Application No.: 09/940,349 Docket No.: JCLA7911

<u>REMARKS</u>

FIG. 8 (PRIOR ART)

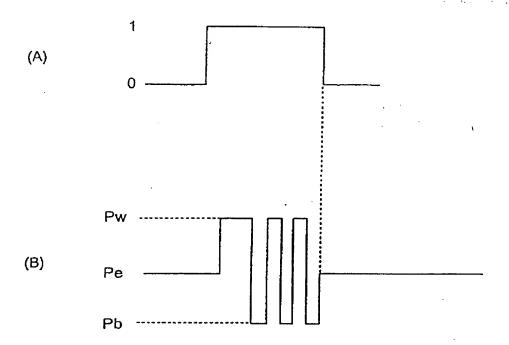
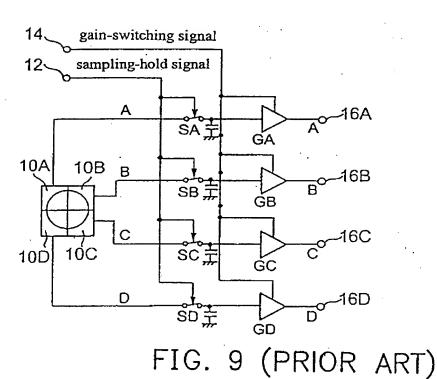
The drawing is objected to because FIG. 8 fails to show "PRIOR ART". Applicants have amended FIG. 8 to add "PRIOR ART". Therefore, this objection has been properly addressed
